Report to the Future Melbourne Committee

Agenda item 6.2

Ministerial Planning Referral: TPM-2020-49 432 - 438 Queen Street, 440 Queen Street and 446 - 450 Queen Street, Melbourne

15 June 2021

23. Queen Victoria Market Precinct Framework Plan 2017 at Figure 1 at Clause 3.0 of Schedule 11 to the Development Plan Overlay

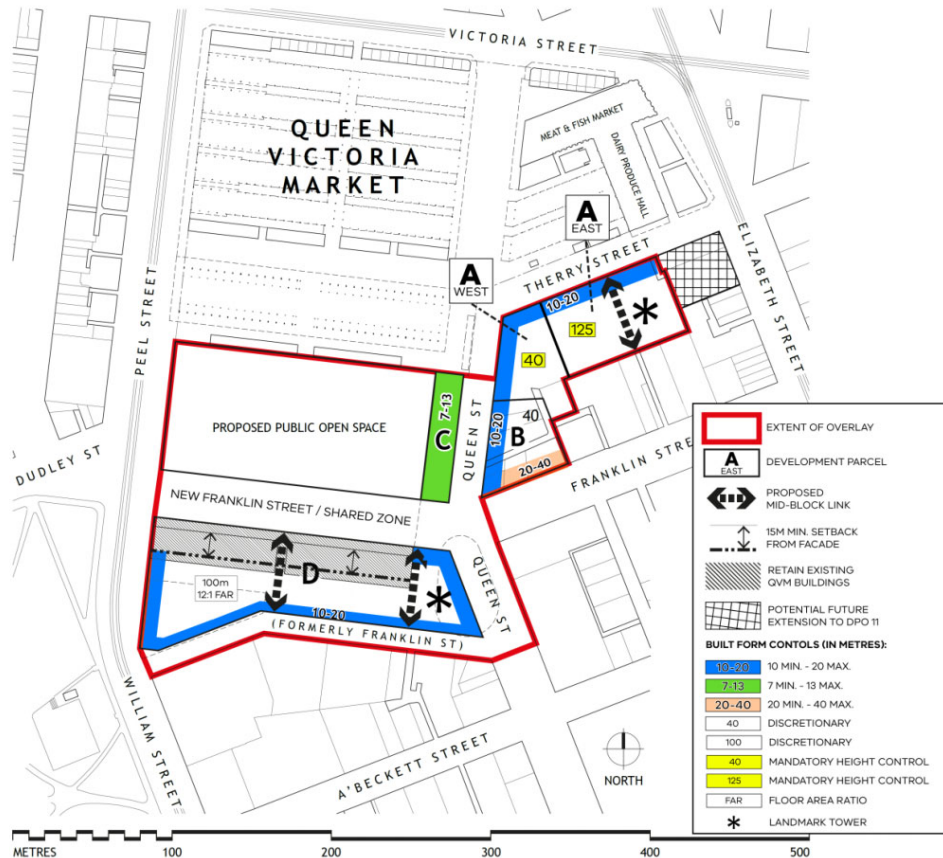
The planning application is generally in accordance with the *Queen Victoria Market Precinct Framework Plan 2017* at Figure 1 at Clause 3.0 of Schedule 11 to the Development Plan Overlay with the exception of the proposed height of the building. The height at 67 metres is well above the discretionary 40 metre sought in the Framework.

The proposed height however is supported because there is a transition in the built form to the south and the building has been sufficiently articulated and modulated which reduces the perception of bulk. There is also no adverse overshadowing of public spaces.

24. Shadow Diagram for the Development Plan (not the Planning Application) for 22 June 10am-3pm - QVM Precinct Parcel B Development Plan April 2021 by BatesSmart Pty Ltd

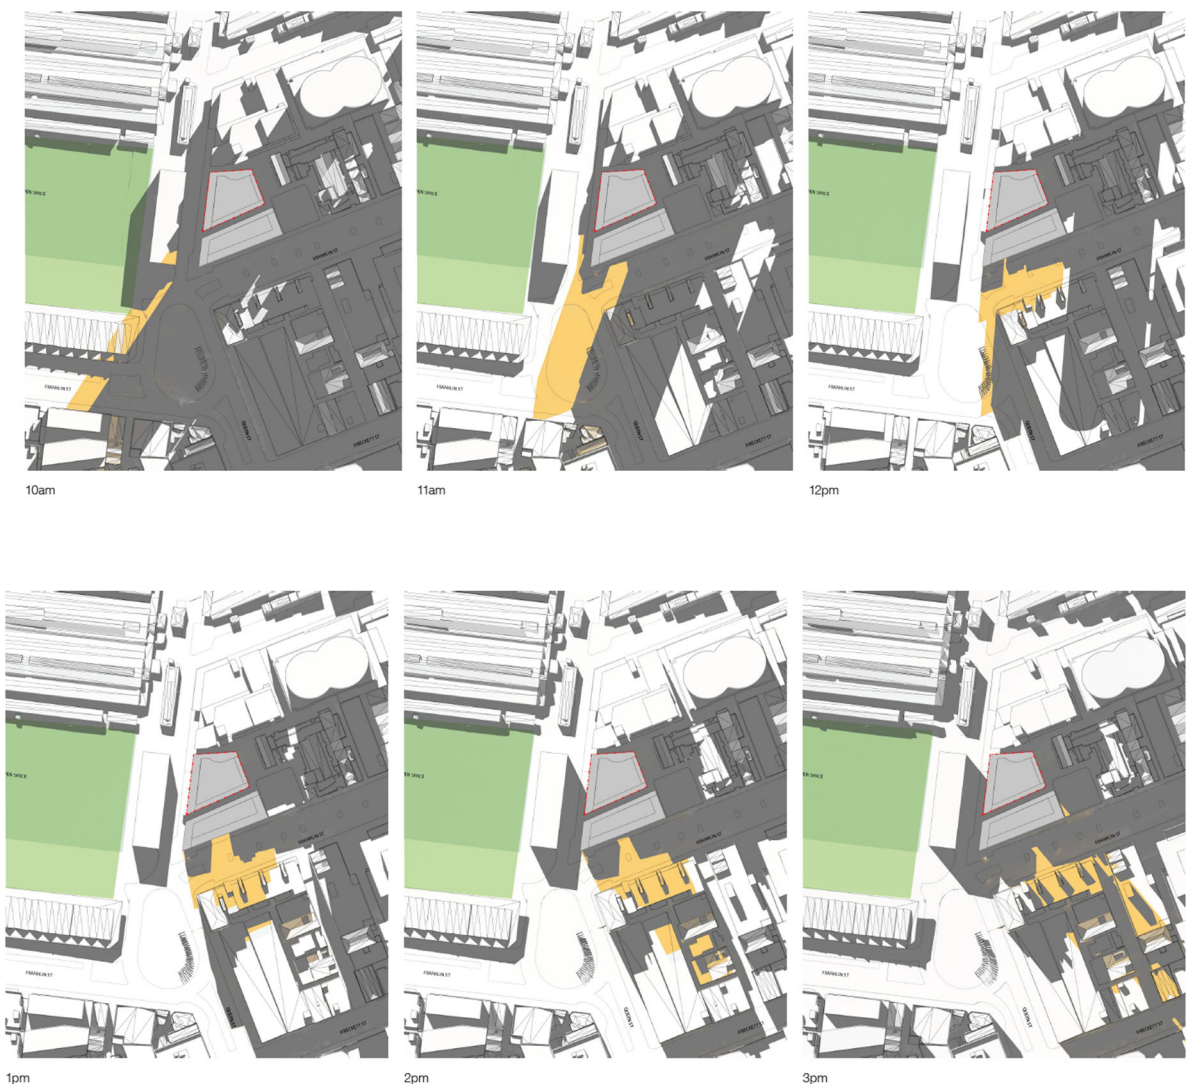
- The application defines and activates the Queen Victoria Market's edge and does not overwhelm the public domain or adversely affect the Queen Victoria Market's heritage significance.
- The profile of the building transitions downwards in scale towards the proposed public open spaces and Franklin Street.
- The building has been configured and designed to ensure appropriate solar access to the proposed public open space (to be created on the car park) and the Flagstaff Gardens (see the shadow studies from the Development Plan below).
- The laneway has been configured to provide through block pedestrian links. No car parking is provided on the Site which is commended. Loading access is proposed to be isolated to the existing east-west laneway.
- Edges of the building have been activated including the north and east laneway.
